PLANNING

RED NOTES/ SHOW AMENDMENTS TO ORIGINAL PLANNING APPLICATION

2 Proposed Block Site Plan
Scale: 1:200

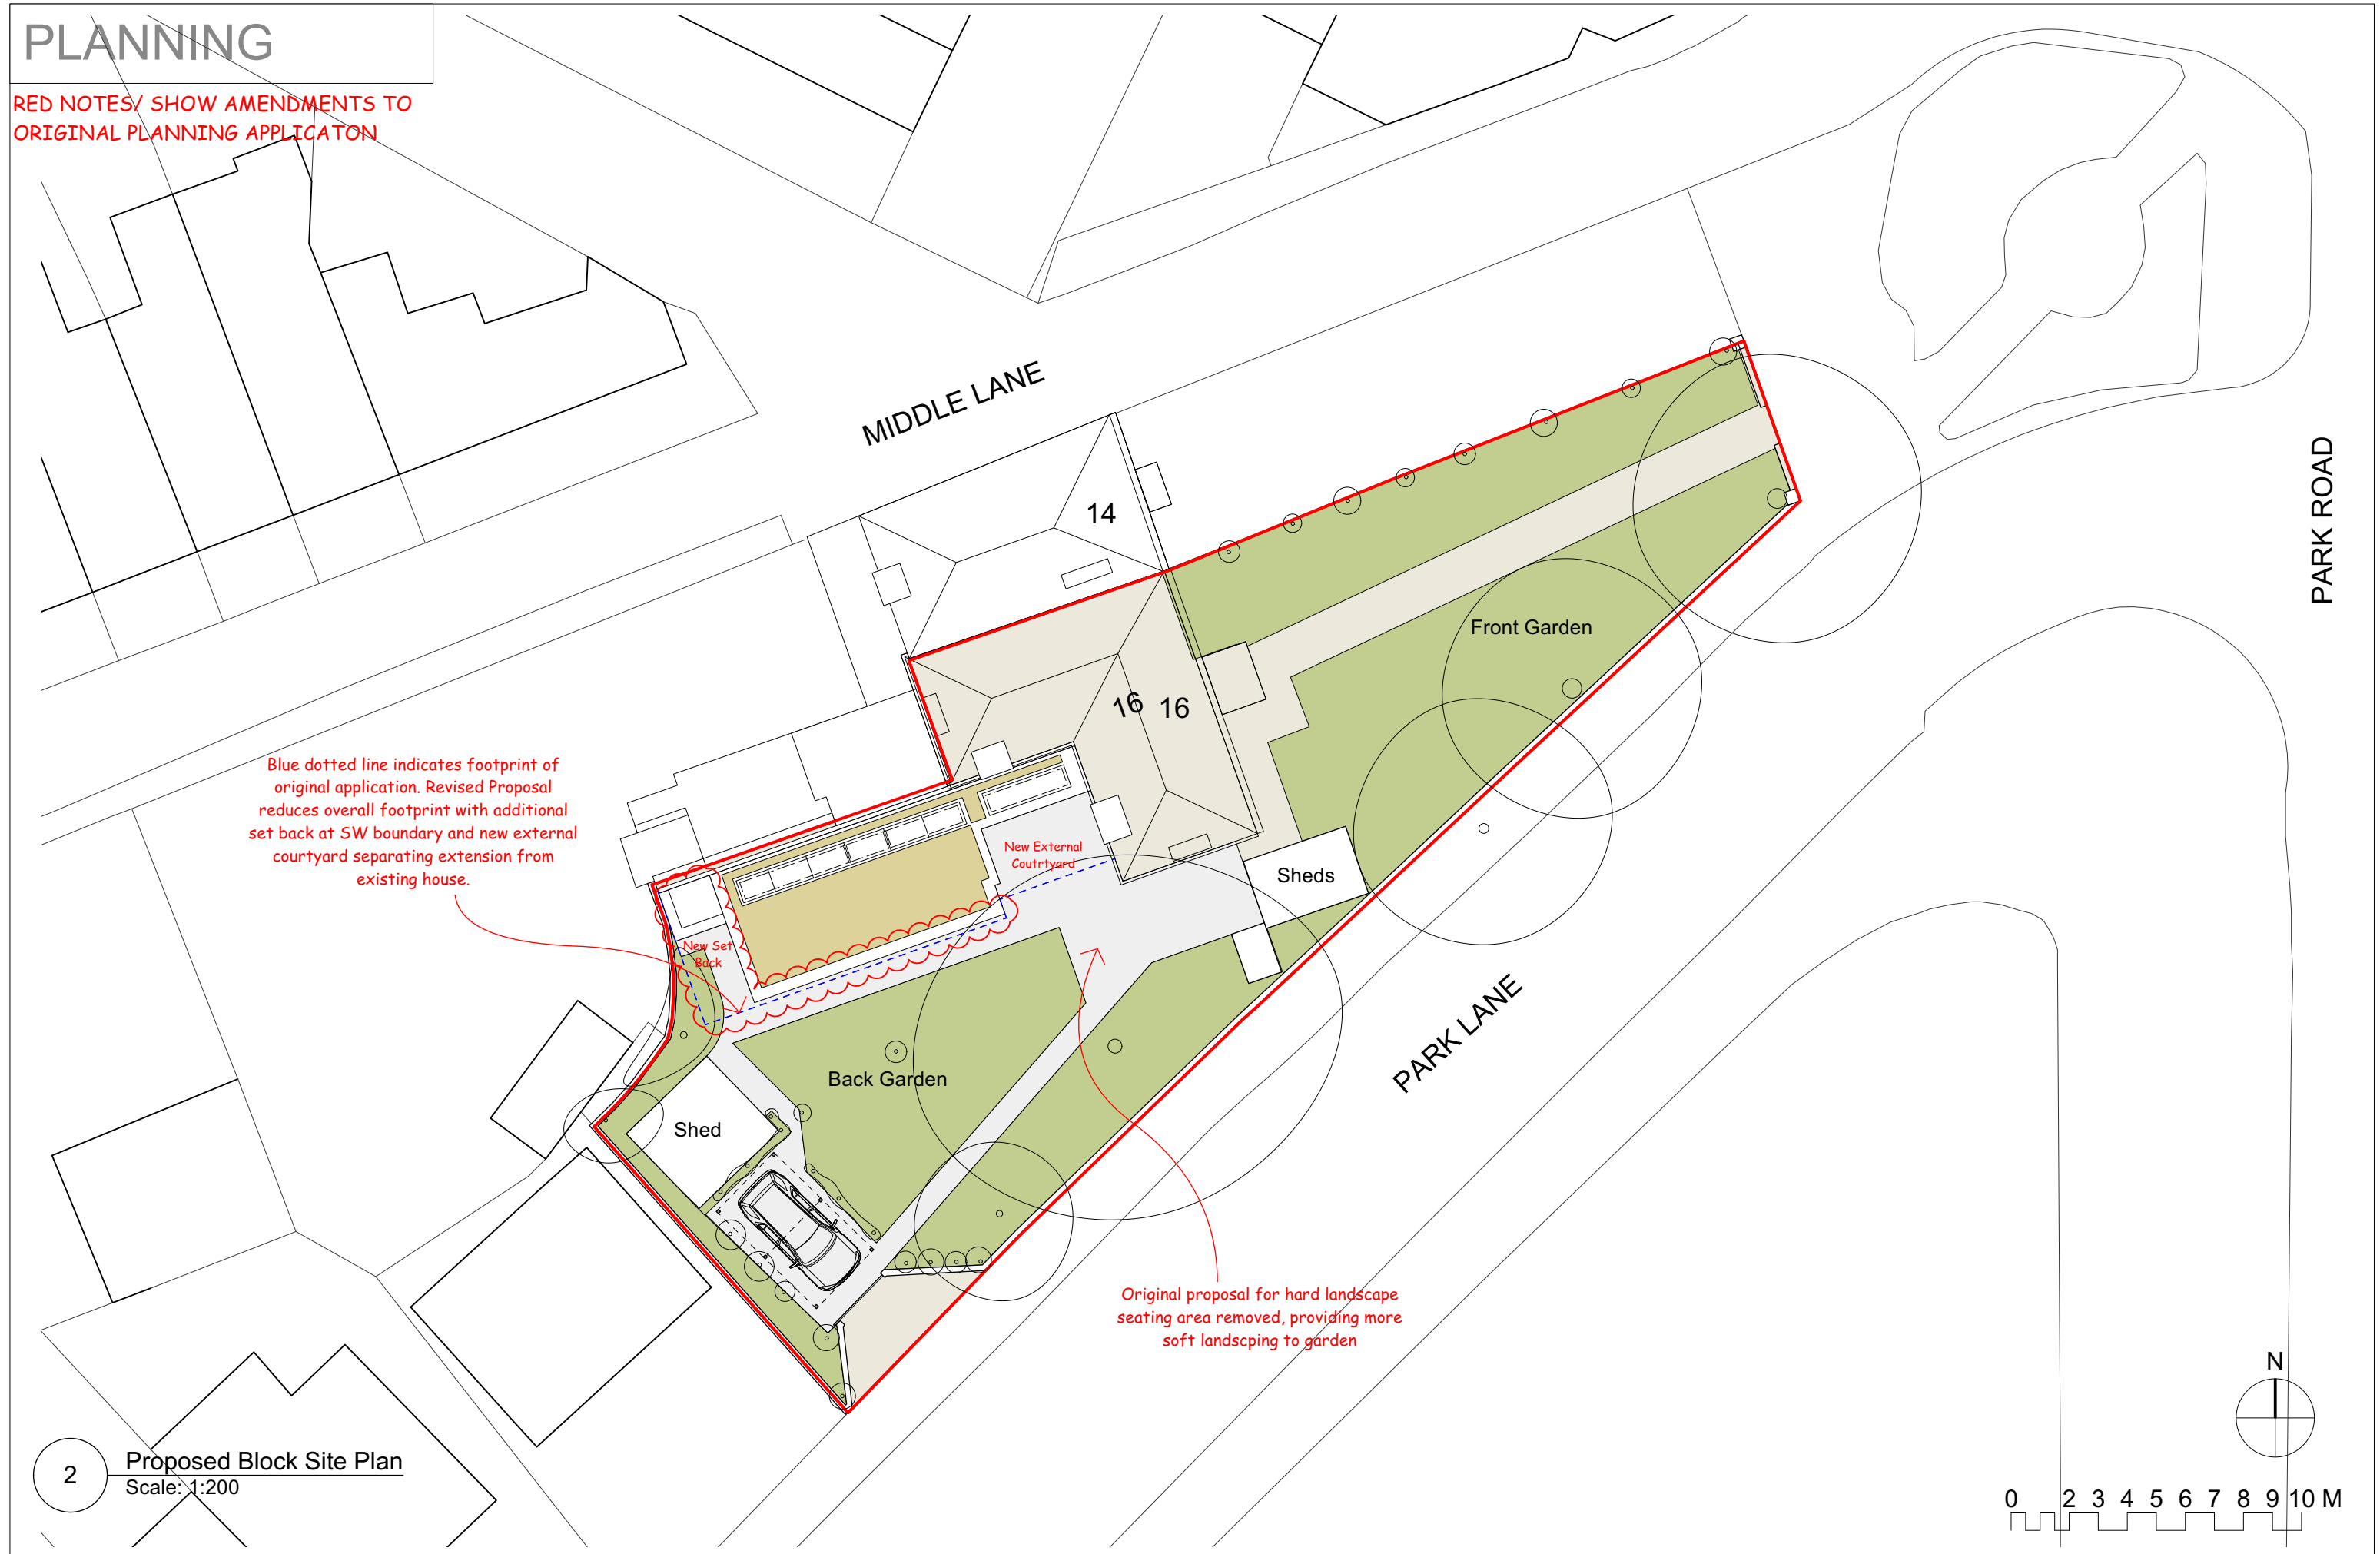
Blue dotted line indicates footprint of original application. Revised Proposal reduces overall footprint with additional set back at SW boundary and new external courtyard separating extension from existing house.

Original proposal for hard landscape seating area removed, providing more soft landscaping to garden
